RECEIPT DATE: 11/3/22 **ONSITE SEWAGE DISPOSAL SYSTEM** P 572677
 APPROVAL DATE: 11/22/2022 **PERMIT: CONSTRUCTION** A _____
 PROPERTY ADDRESS: 7005 Colt Place
 SUBDIVISION: Willowshire LOT: 24 TAX ID: _____
 CONTRACTOR: Fogles Septic Clean Inc. EMAIL: kim@foglesinc.com
 CONTRACTOR ADDRESS: 580 Obrecht Road, Sykesville, MD 21784 PHONE: 410-795-5670
 PROPERTY OWNER: Toll Mid Atlantic LP Co Inc. EMAIL: _____
 OWNER ADDRESS: 250 Gibraltar Road, Horsham, PA 19044 PHONE: 410-872-9105
 SEPTIC TANK SIZE (GALLONS): 2000 TANK MANUFACTURER: Back River Pre Cast
 PUMP MODEL: _____ PUMP SIZE _____ PUMP TANK CAPACITY: _____

ONSITE SEWAGE DISPOSAL SYSTEM DESIGN PLAN
LOT 24
WILLOWSHIRE
LIBER 18479, FOLIO 296
PLAT NO. 25505
ELECTION DISTRICT No. 5
HOWARD COUNTY, MARYLAND
ADDRESS: 7005 COLT PLACE
DAYTON, MARYLAND 21036

ONSITE SEWAGE DISPOSAL SYSTEM DESIGN PLAN
LOT 24
WILLOWSHIRE
LIBER 18479, FOLIO 296
PLAT NO. 25505
ELECTION DISTRICT No. 5
HOWARD COUNTY, MARYLAND
ADDRESS: 7005 COLT PLACE
DAYTON, MARYLAND 21036

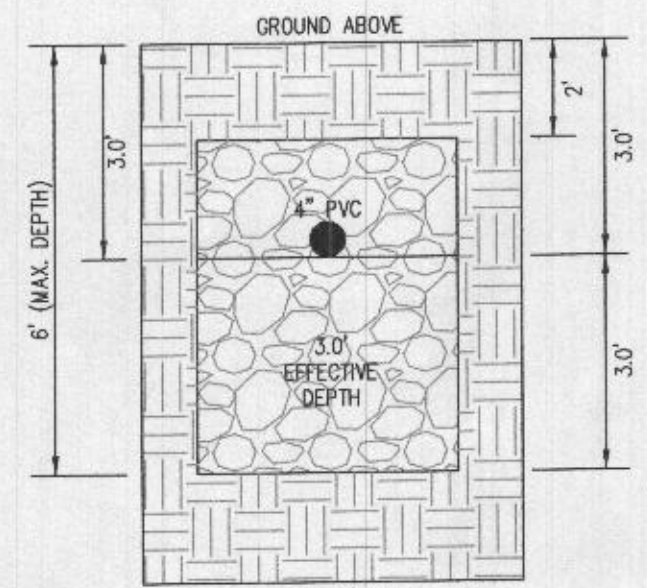
11/15/22 - Adjusted T₁ & T₂. Shifted 5" downhill. original elevation shot in field was 5" difference. T₄ & T₅ look good. OK to start T₃ next to d-box (SP/KW)

11/17/2022 Tank loc, Dbox installed; 4 x 39' trenches completed, inspect tie-in to DBox. 11/18/2022 Trenches complete Reinspect D box speed levels. 11/20/22 Dbox leveled OK to cover all work (KW)
